SUBJECT: Comanche Peak Nuclear Power Plant, Docket Nos. 50-445 AND 50-446,
Compliance with NRC Order Modifying Licenses with Regard to Reliable Spent Fuel
Pool Instrumentation (Order Number EA-12-051) (TAC NOS. MF0862 AND MF0863)

Attachment 1 Comanche Peak Nuclear Power Plant (CPNPP), Compliance with
NRC Order EA-12-051, Order Modifying Licenses with Regard to Reliable Spent
Fuel Pool Instrumentation

Attachment 2 CPNPP Spent Fuel Pool Level Instrumentation Equipment Locations

RESPONSES TO REQUEST FOR ADDITIONAL INFORMATION IN NRC INTERIM STAFF EVALUATION

SFPLIS Equipment Locations- SFP Area

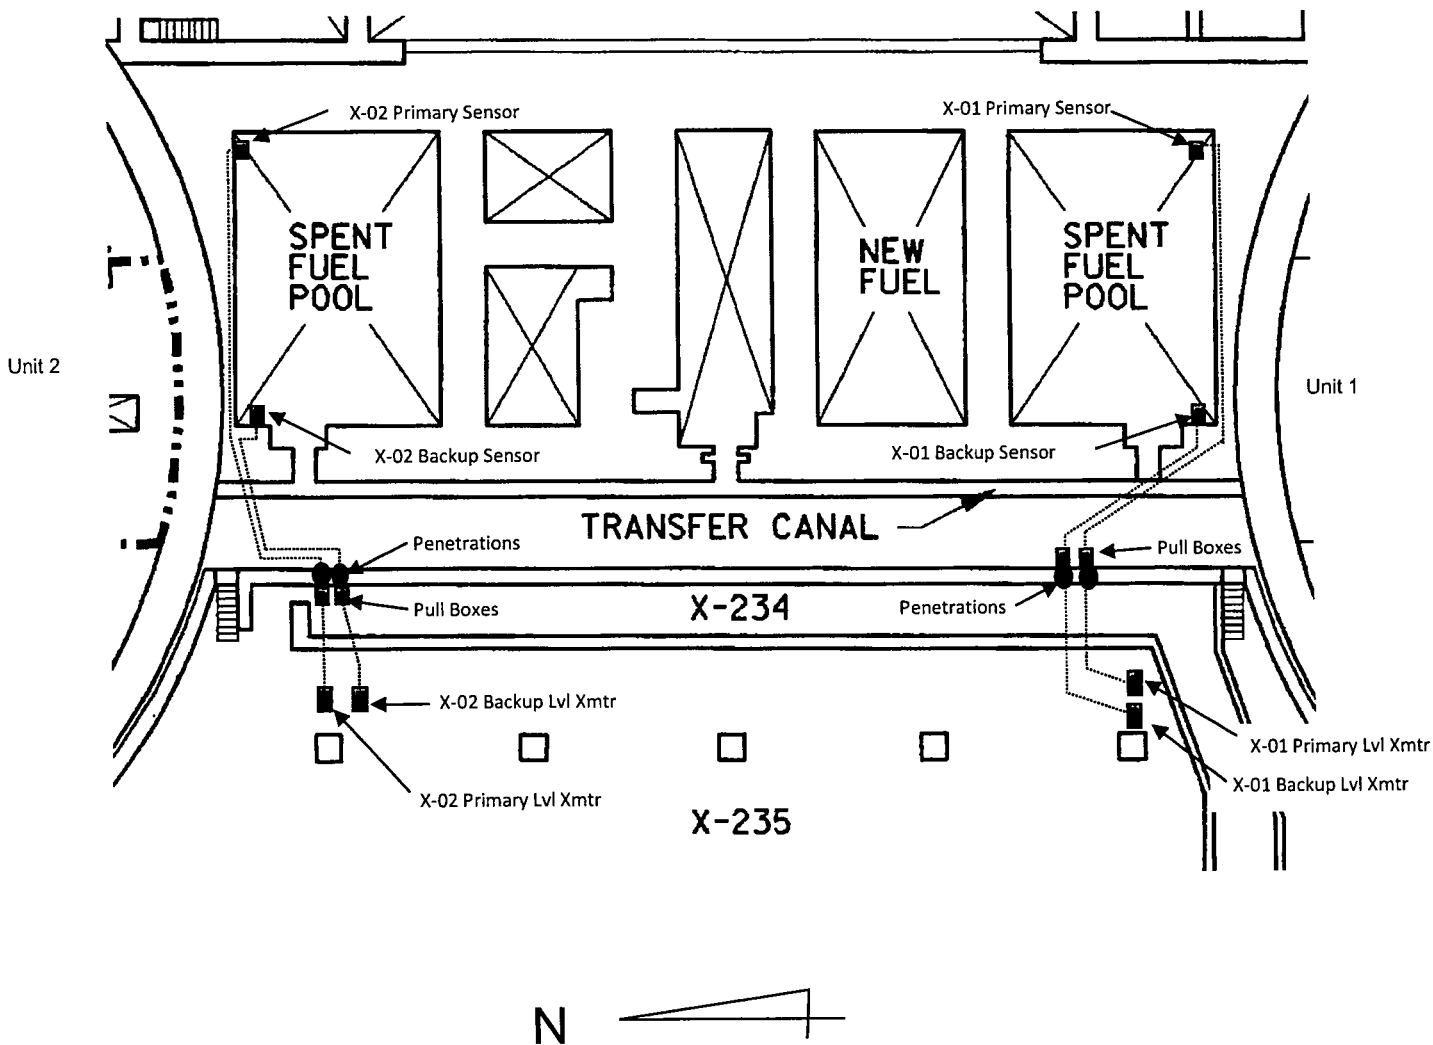
- a) **The final locations/placement of the primary and back-up SFP level channel components, cable routing, credited display units, and wireless instruments.**

See Attachment 2 for SFPLIS Equipment Location drawings.

The spent fuel pool X-01 primary instrument channel sensor is mounted on the south side of the pool, near the east end. From the primary sensor, the primary coaxial signal cable raceway is routed west along the south side of the pool until it enters a fire/radiation barrier wall penetration to the adjacent Auxiliary Building 852' elevation, room X-235.

The spent fuel pool X-01 backup instrument channel sensor is mounted on the west end of the pool, near the south side wall. This places the backup sensor between the south side wall and the gate to the transfer canal, and a least 30 feet from the primary sensor. From the backup sensor, the backup coaxial signal cable raceway is routed west around the transfer canal until it enters a second fire/radiation barrier wall penetration to the adjacent Auxiliary Building 852' elevation, room X-235.

The spent fuel pool level instrumentation for pool X-02 is a mirror image of the instrument layout in X-01. In the Auxiliary Building the raceway for both pools maintain physical separation of the primary and backup instrument channel signal cables and power cables that meet site standards for separation for Class 1E conduit.
